CONTRACT NUMBER DE-AC27-08RV14800 - WASHINGTON RIVER PROTECTION SOLUTIONS LLC SUBMITTAL OF HANFORD FEDERAL FACILITY AGREEMENT AND CONSENT ORDER INTERIM MILESTONE M-045-91I DELIVERABLE

RPP-IQRPE-50028, Single-Shell Tank Structural Integrity Assessment Report, Revision 0.

Single-Shell Tank Structural Integrity Assessment Report

E2.0 ANALYSES OF RECORD QUESTIONS AND ANSWERS

Figure 1: Type-II Temperature and Waste Height History

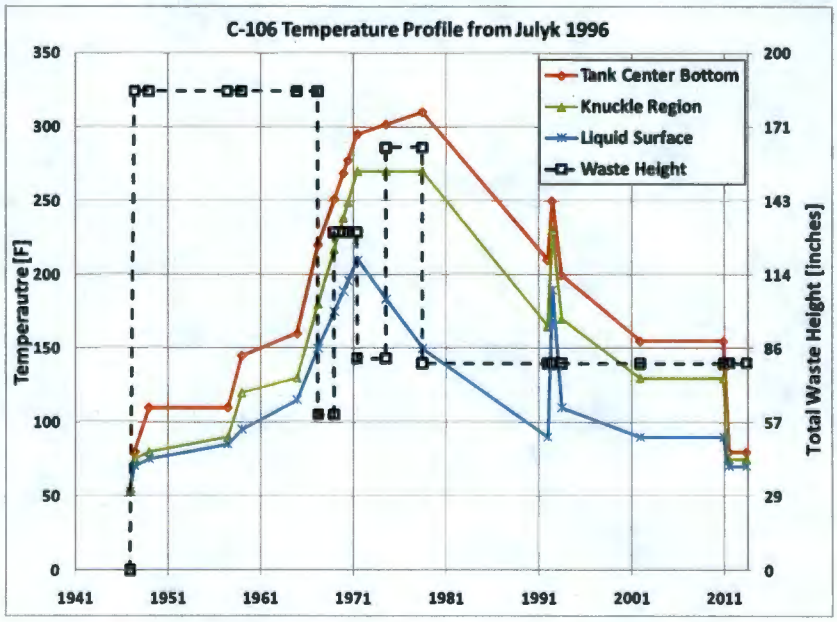
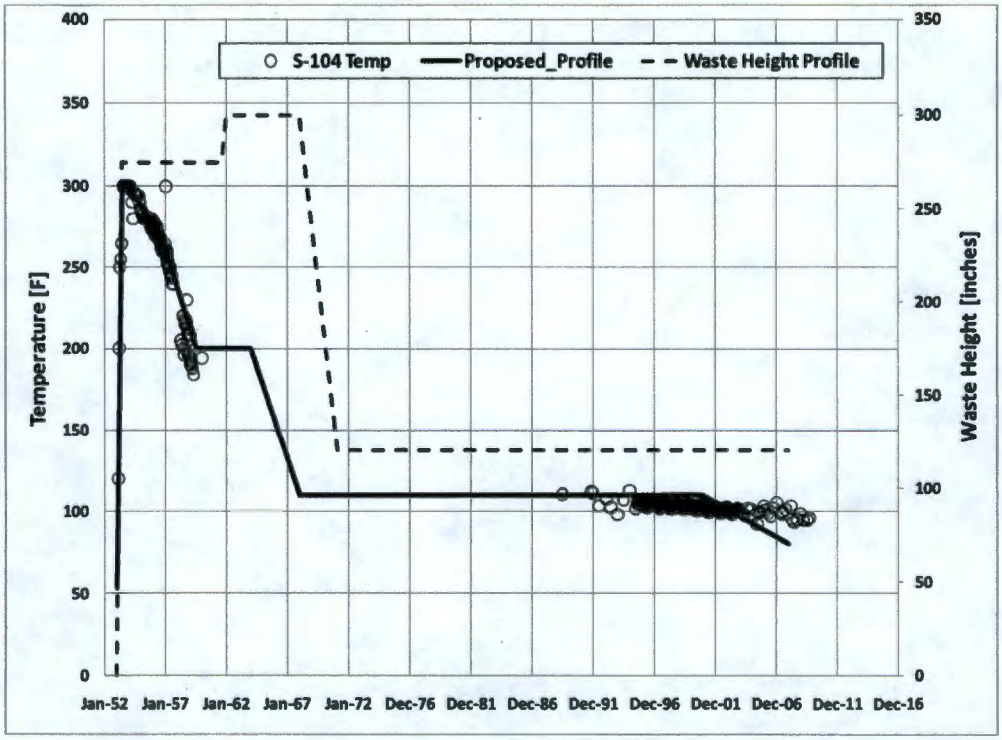
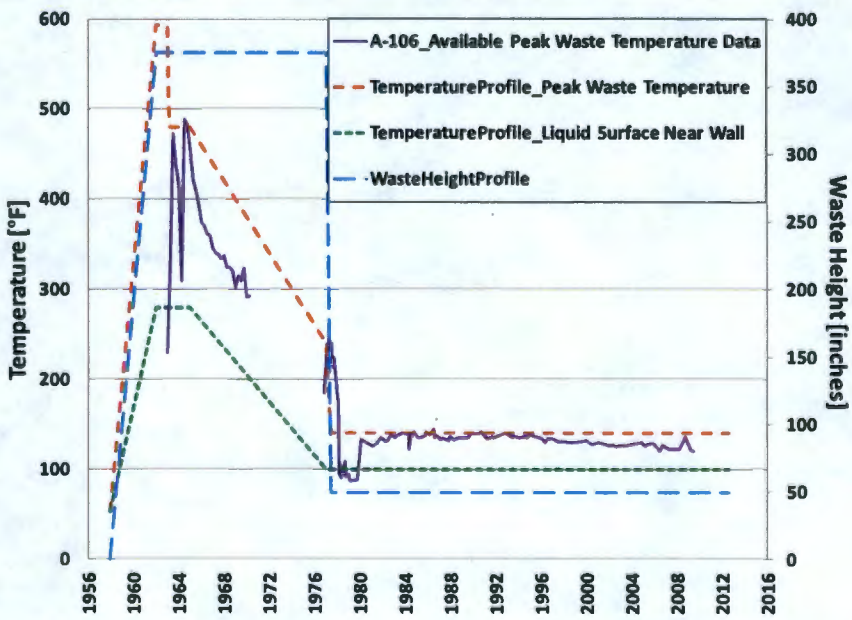
The Type II AOR applied the temperature history in Figure 1 and found that the calculated tank temperatures were similar to the bounding temperatures of the previous tank C-106 analysis. Both the Type III and Type IV thermal transients begin with steep temperature ramps to the highest temperature recorded for each tank type (Figures 2 and 3) to ensure that the maximum amount of concrete degradation was included in the analysis.

IQRPE Closing Comments: The question has been thoroughly answered, so we concur with the PNNL response.

Figure 6.29: SST Type II Seismic Model BES: Soil Stresses (kip/ft^2) – Vertical Component

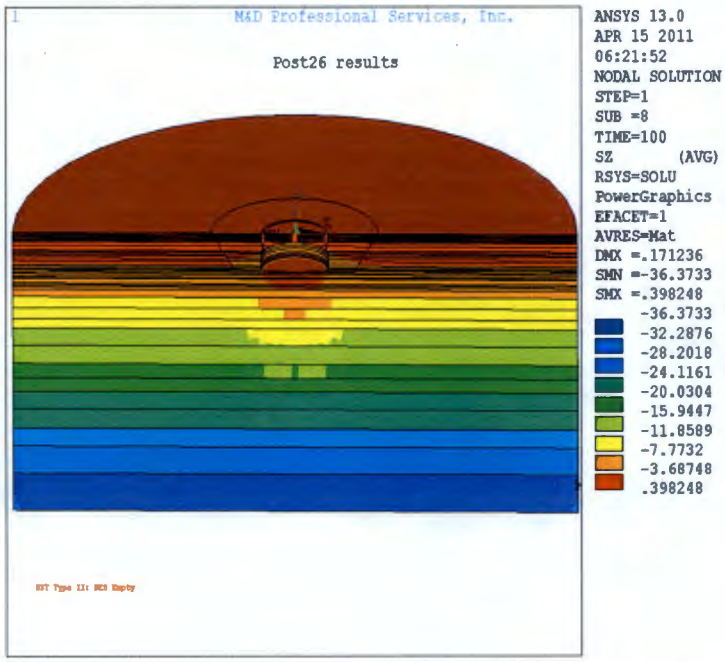
IQRPE Question: The seismic model produces 400 psf uplift at the soil surface under dead load only in RPP-RPT-49989 Figure 6.29. Can you explain these results and why they are acceptable?

PNNL Response: 0.4 kip/ft^2 is approximately zero for the contour range used in Figure 6.29. The finite element code first calculates the nodal forces and displacements in the soil, then the stresses at the internal integration points, and finally extrapolates the integration point stresses to approximate the nodal stresses at the surface. The nine stress contours on Figure 6.29 range from -36.4 to 0.4 kip/ft^2, with the red contour from -3.69 to 0.40 kip/ft^2. Zero is within the red contour. The 0.4 kip/ft^2 maximum value is shown locally in the soil at the left side of the tank dome. If finer contours were chosen with one ending at 0.0, we expect that most of the surface would be at zero, and the 0.40 kip/ft^2 value would be evident and localized.

IQRPE Closing Comments: The question has been thoroughly answered, so we concur with the PNNL response.

Figure 6.12: Seismic Model Soil/Concrete Contact Element Normal Pressure for At-Rest Calibration – Gravity Only

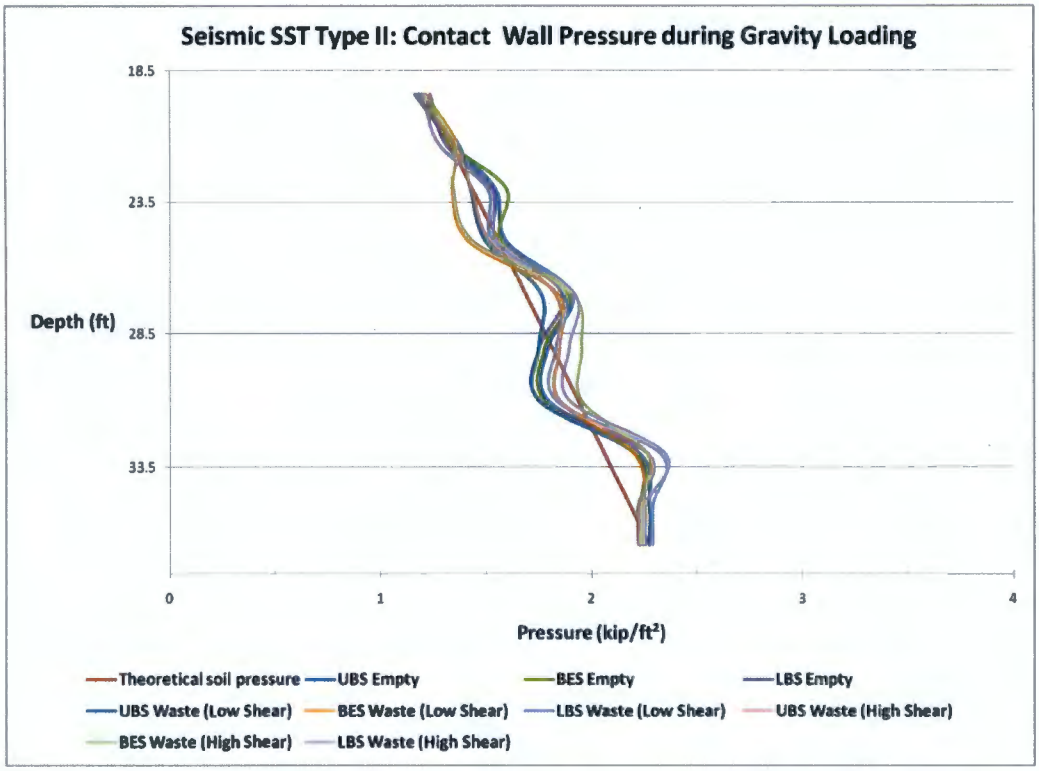
IQRPE Question: The soil pressure at the side walls produces odd at rest pressure results against the tank side walls (see RPP-RPT-49989 Figure 6.12). Appendix H discusses these results as a function of geometry of the tank. Was this phenomena also shown in the axisymmetric model or only the shell model? With a well-defined phenomenon as pressure increase along depth of soil it is odd to see a wave like distribution of soil pressure. Has this type of pressure distribution been observed/measured in real world tests?

PNNL Response: Figure 6.12 shows the approximated soil pressures from the 180° seismic model. Appendix H is the axisymmetric static model, which is actually a 3D wedge (with symmetric boundary conditions) because the STIF65 concrete elements are 3D. The waviness of Figure 6.12 is an artifact of the finite element modeling approximation. We don't expect that real-world tests would show similar behavior.

IQRPE Closing Comments: The question has been thoroughly answered, so we concur with the PNNL response.

Figure 11.11: Load-Displacement Response of Nominal Concrete Under 5.8 ft of Soil with Local Load

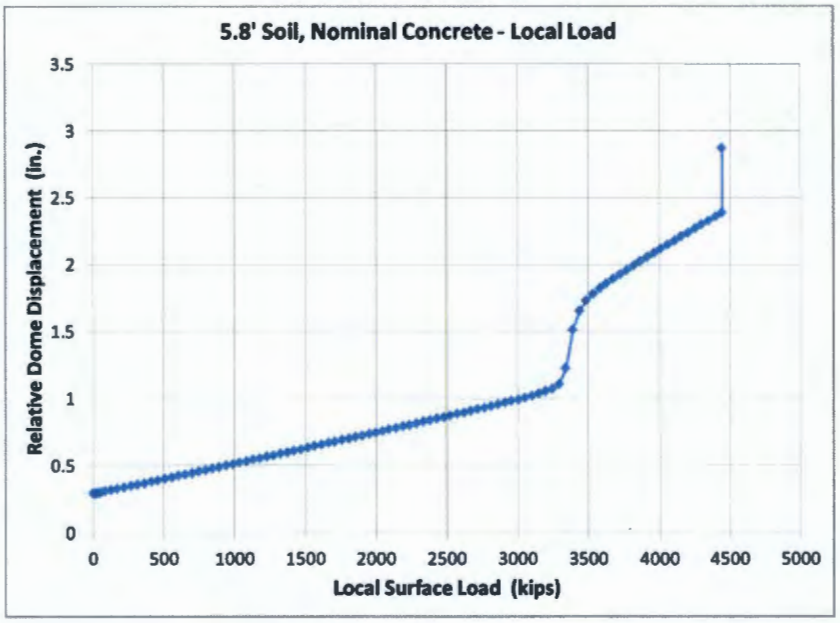
IQRPE Question: In the load-displacement response graphs for the limit analysis, what causes the non-linear behavior in each of the graphs (RPP-RPT-49989 Figure 11.11)? Based on RPP-46442 Figure 4.5, it seems that this behavior is similar to the ASME collapse load but the collapse limit line is not shown in the plots so it is difficult to discern.

PNNL Response: The nonlinear slope change in RPP-RPT-49989 Figure 11.11 load/deflection curve results from extensive cracking in the dome and the haunch concrete. The slope change is more pronounced for the local limit load cases than the uniform limit load cases.

IQRPE Closing Comments: The question has been thoroughly answered, so we concur with the PNNL response.

Figure 8.18: Run 2, ACI D/C Ratios for LC1, BES + BEC, No Creep

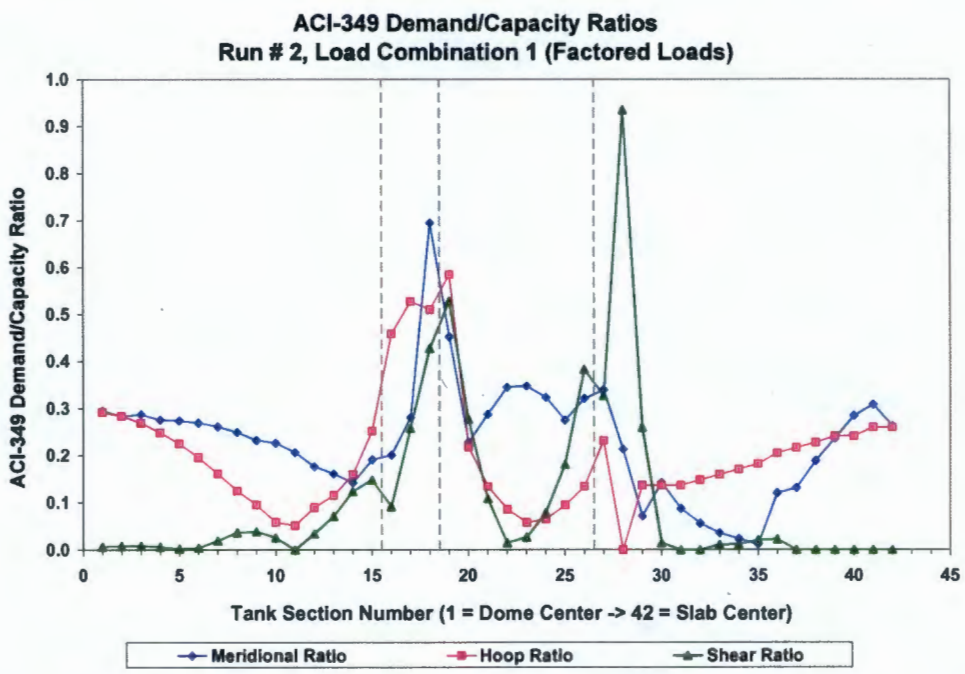
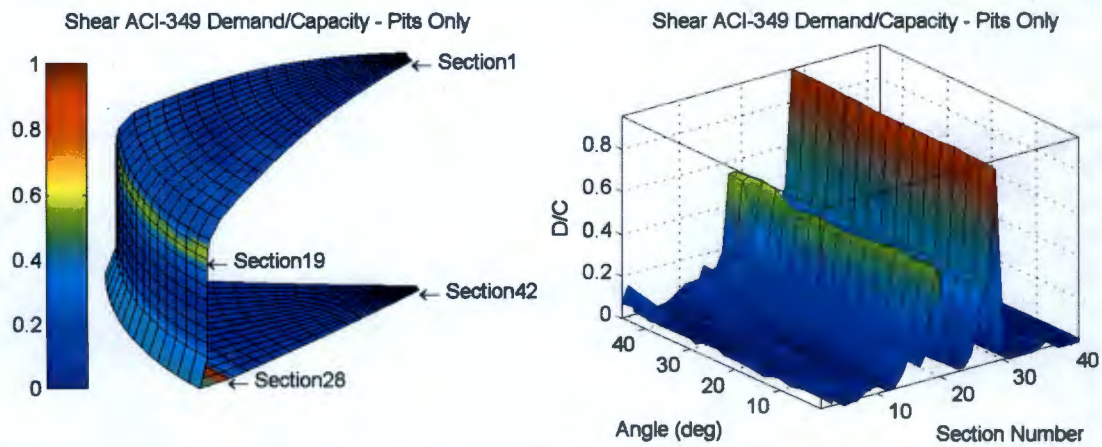
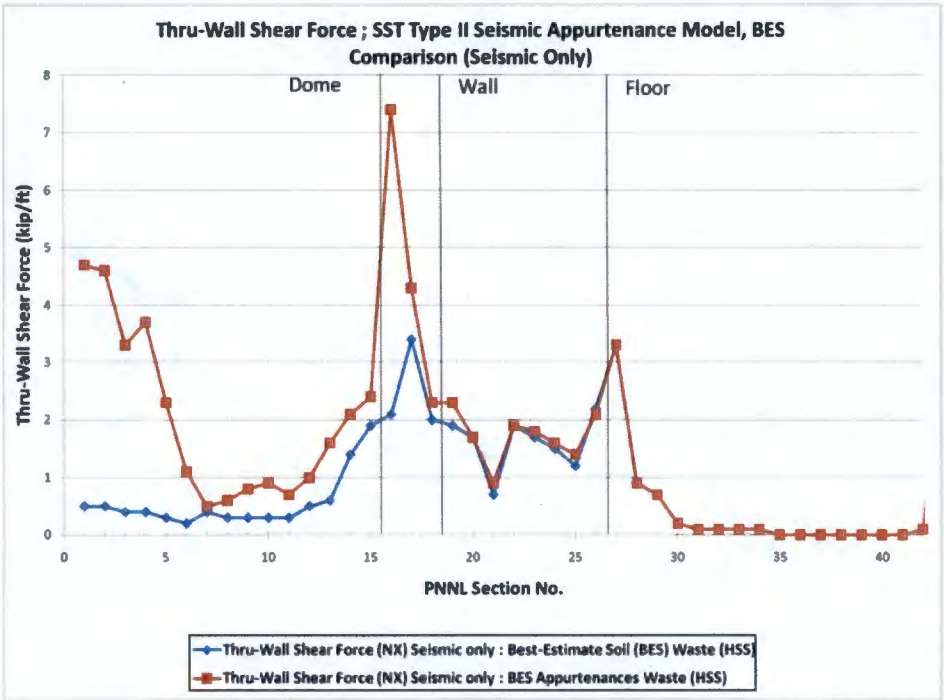
IQRPE Question: For reference, RPP-RPT-49989 Figure 10.44 shows a localized exceedance of shear capacity (D/C=1.07) in adjacent elements at the top of the wall. The reviewer says to average the shear stress over a distance 4× the wall thickness. In the discussion, it is mentioned that even doing this still leaves the area over capacity (D/C=1.06). It is stated that the seismic demands are 10-30% conservative in general, but that is not reflected at each location. It is also stated that the combination of appurtenances is not present in any single Type II tank. Those considerations could give credence to the argument that the tank is conservatively analyzed. But, the tank-to-tank interaction is not taken into account, which was stated can increase the demand by 10-20%. Why was the model then not revised to better reflect the actual conditions of a tank (or 2) to then present results that show the tank was under stressed?

Figure 8.18 Factored static loads, BES+BEC, no creep, shows shear peak D/C=0.52 at section 19.

Figure 10.9 Appurtenance model, factored static loads, BES+BEC, no creep, shows shear peak D/C~0.55 at section 19.

Figure 10.33 Concrete tank through-wall shear – BES, HSS waste comparison with and without appurtenances (seismic only),

IQRPE Closing Comments: The question has been thoroughly answered, so we concur with the PNNL response.
